HOSHIZAKI AMERICA, INC.

SERVICE BULLETIN

SB09-0005R1

Subject: KML- WATER PUMP CHANGE.

New pump capacitor (4A2128-05)

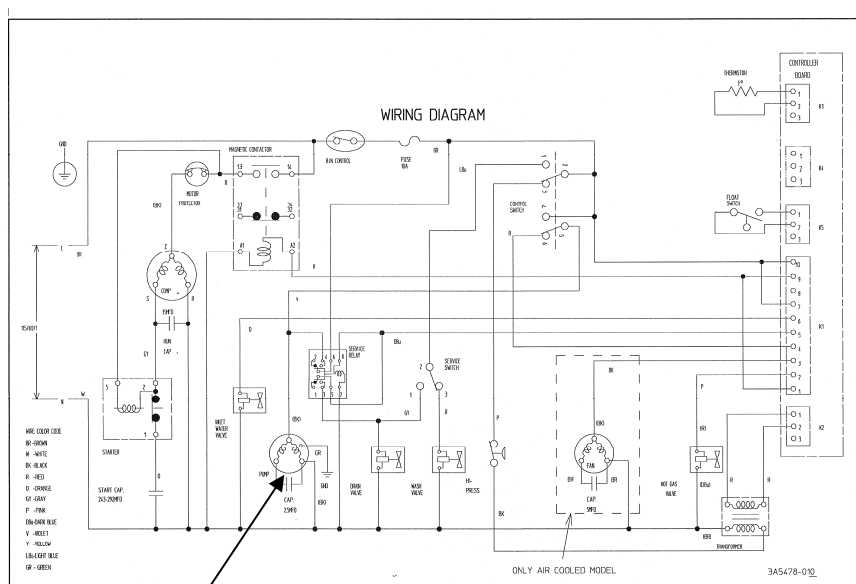
Beginning in June, 2009 the KML series water pump manufacture will change. The new part number will be 4A4259-01. In addition to the new pump an additional 2.5 MFD capacitor (4A2128-05) will be added to the control box. This new pump is not interchangeable with the current pump motor assembly.

Below are the starting serial numbers for the new pump as well as the new wiring diagram showing the additional capacitor. If you have any questions concerning this change please contact Technical Support department at 1-800-233-1940
